Architectural Control Committee
Plan and Specification Review Determination
PATIO, DECK, A/C, HOT TUB APPLICATION

16833

Address 16312 18th AVE. S.E.

Outdoor Unit Single Zone Heat Pump Ductless System

Proposed Construction/Location
Drawing (Property sketch):

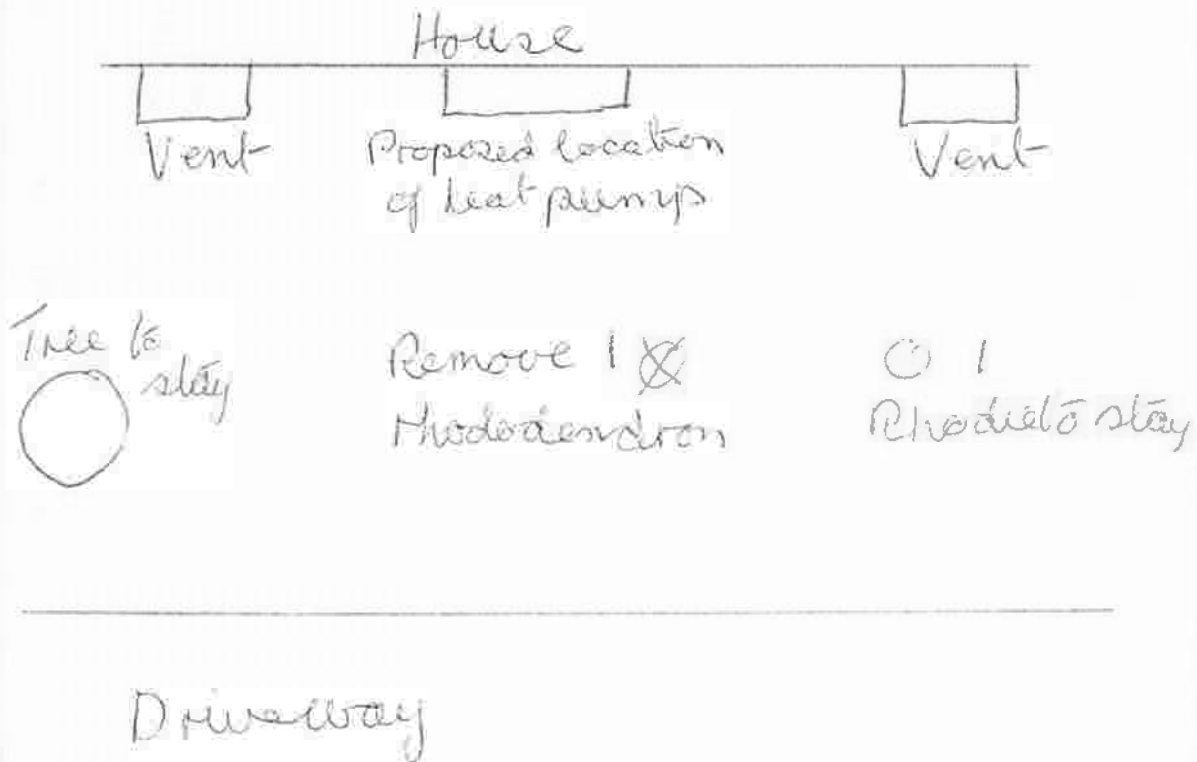
If visible from the street, owner agrees to enclose heat pump with short fence painted same color as the house.
